OVER THE SOLDERING IRON

PREPARED FOR THE INFORMATION OF RCA
VICTOR DISTRIBUTORS' SERVICE MANAGERS

SERVICE DIVISION - RCA MANUFACTURING COMPANY INC. - CAMDEN, N.J. MARCH 17, 1939.

Models 94BK2 and 94BT2

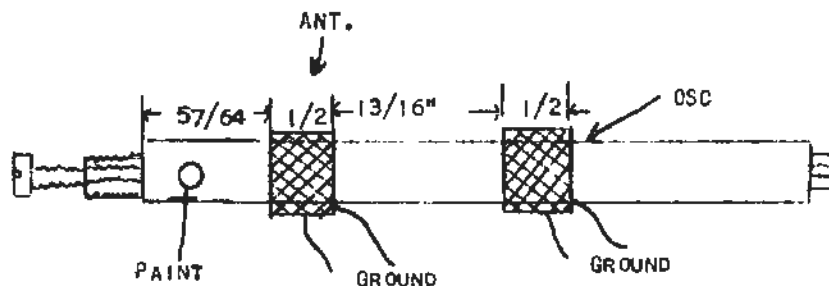
Before aligning these receivers, it is suggested that the following trimmer and core adjustments be pre-set to the mechanical dimensions given below:

1. The three trimmer condensers C30, C3, and C2 on rear apron should be set to maximum capacity (screws turned full clockwise) and then unscrew each about $1/4$ turn.
2. Unscrew L4 to its minimum inductance position (screw all way out) and then screw in 8 full turns.
3. Unscrew L6 to its minimum inductance position (screw all way out) and then screw in 6 full turns. Do not run this adjustment screw in too far (more than 12 to 15 turns) as the Core will contact a lug on this coil at plus "B" potential causing a high resistance short and no signal (dead set).
4. Screw L9 all the way in and then unscrew 13 full turns (about $3/8$ inch of threads exposed).

When servicing these receivers, do not shift the positions of either the oscillator section (front) or antenna section (rear) on any of the four tandem push button coil assemblies, since their positions on the form governs the tracking between the two circuits. The illustrations below show the proper spacings of coils. If necessary, seal the coils securely to the form with wax to the dimensions shown.

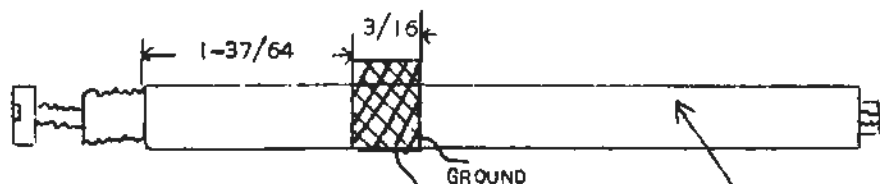
The coils are coded with a spot of paint as follows:-

Black - Stock #32250
 White - Stock #32251
 Red - Stock #32252
 Green - Stock #32253

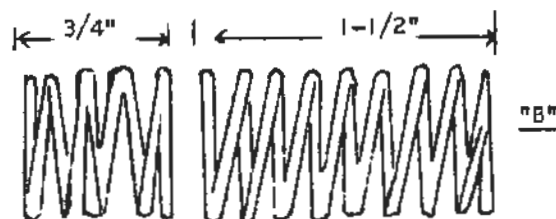
Spring combination "A" corresponding to dimensions shown should be installed on each of two motor mounting studs supporting field coil assembly of motor (nearest rear of cabinet) with $5/8$ " spring above motor board and $1\ 3/16$ " spring below.

Spring combination "B" corresponding to dimensions shown should be installed on motor stud at end of gear case (nearest front of cabinet) with $3/4$ " spring above motor board and $1\ 1/2$ " spring below.

SPIDER WEB ANTENNA - Dimensions

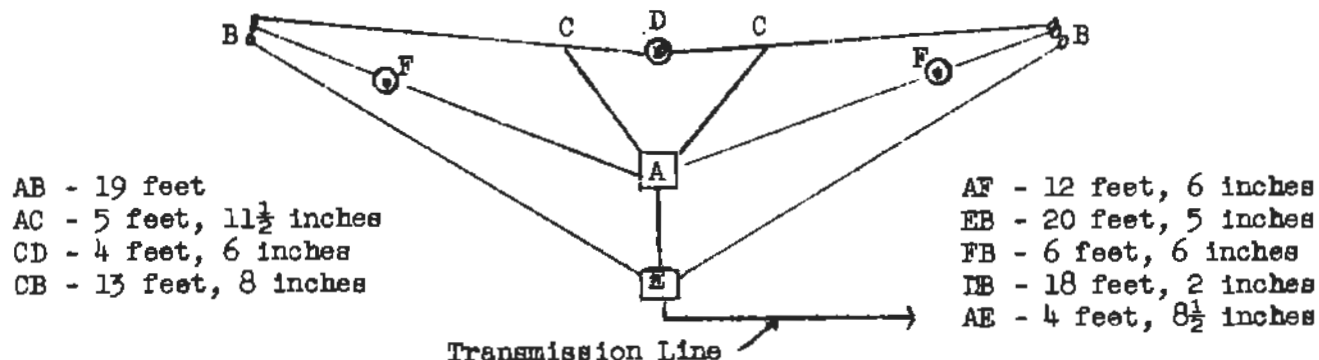
The following information giving correct dimensions of the Spider Web Antenna will enable an accurate check and correction where difficulty is encountered in obtaining the proper suspension. Measurements are given from end loops of leads to centers of holes in insulators.
